UNITED STATES PATENT AND TRADEMARK OFFICE

10/552,753

Office Action Summary	Application No. 10/552,753	Applicant(s) SONG, SUNG-WOOK	
	Examiner IVES WU	Art Unit 1797

DETAILED ACTION

FIG. 1

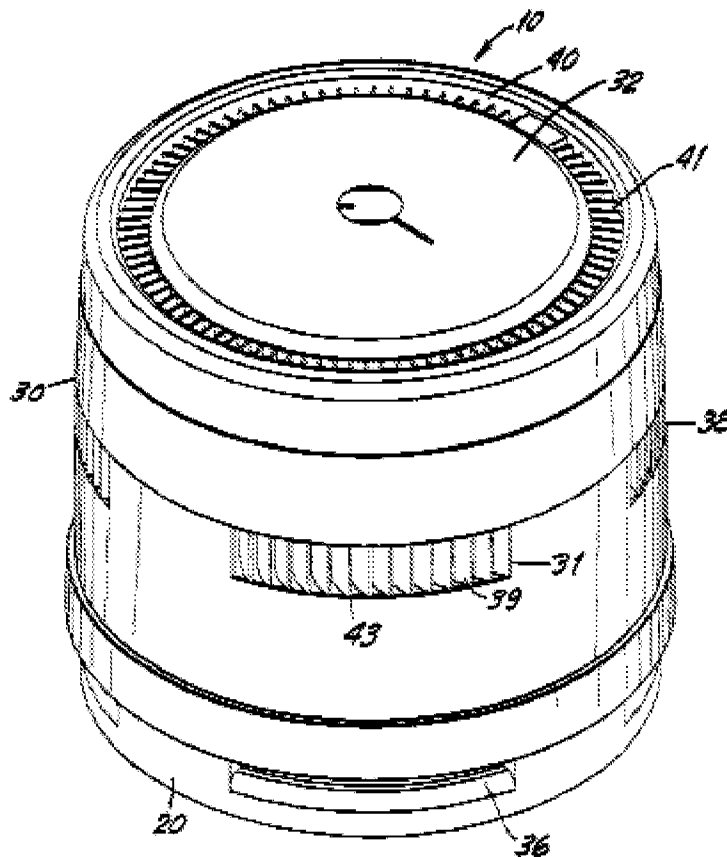
As to a cylindrical body fixed to a bottom circular disc wherein an entire appearance of the same is formed of a grill part in an air cleaner in **independent claim 1**, Chiu et al (US 5753000A) disclose filter air cleaner (Title). A portable air cleaner having a cylindrical filter element mounted on a circular base and encased by cylindrical cover (Abstract, line 1-3). As illustrated in the Figure below, additional air inlet openings 38 may be disposed about the circumference of side wall 34. It would be obvious to have an entire appearance to be formed of a grill part because of design choice. *MPEP* §§ 2144.04. As evidenced by Davis et al (US 5435817A) in Figure 2, which shows the entire circumference of air inlet grill.

FIG. 7

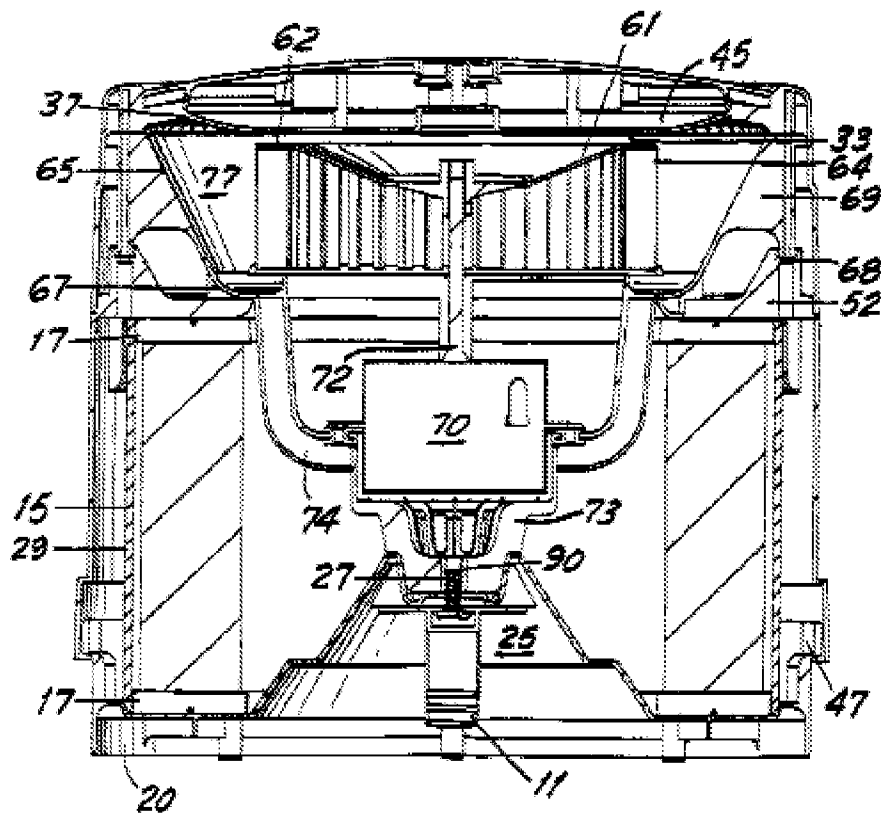
As to air supply unit assembly including an air guide member capable of guiding the air flowing from the air hole to the air discharge hole in the upper direction, not the bottom in **claim 5**, Chiu et al (US 5753000A) disclose the aid deflector dish 69 as shown in the Figure 7, which reads on the features of instant claim.
